TVA-BFN-TS-409

April 15, 2003

**BROWNS FERRY NUCLEAR PLANT (BFN) - UNITS 1, 2, AND 3 - TECHNICAL SPECIFICATIONS (TS) CHANGE 409 - ADOPTION OF TS TASK FORCE (TSTF) TRAVELER - 287, REVISION 5 - CONTROL ROOM VENTILATION SYSTEM ENVELOPE - ALLOWED OUTAGE TIME**

### Technical Specifications (TS) Change 409 Adoption of TSTF-287, Revision 5 Control Room Ventilation System Envelope Allowed Outage Time

3.7.3 Control Room Emergency Ventilation (CREV) System

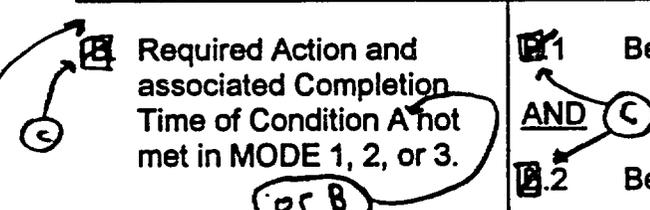
The main control room boundary may be opened intermittently under administrative control.

B. Two CREV subsystems inoperable due to inoperable control room boundary in modes 1, 2, and 3.	B.1 Restore control room boundary to OPERABLE status.	24 hours
---	---	----------

for reasons other than Condition B

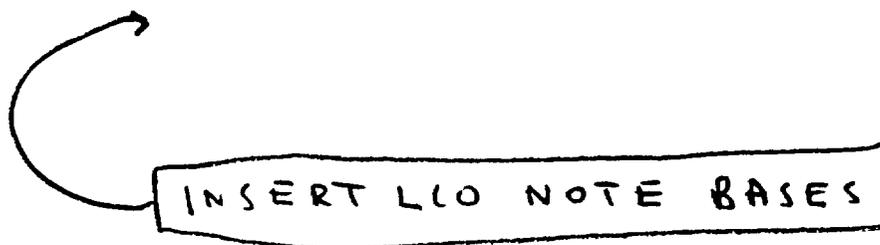
INSERT LLO NOTE BASES

INSERT  
LCO NOTE BASES (BWR 3.7.4, MCREC System)

The LCO is modified by a Note allowing the main control room boundary to be opened intermittently under administrative controls. For entry and exit through doors the administrative control of the opening is performed by the person(s) entering or exiting the area. For other openings, these controls consist of stationing a dedicated individual at the opening who is in continuous communication with the main control room. This individual will have a method to rapidly close the opening when a need for main control room isolation is indicated.
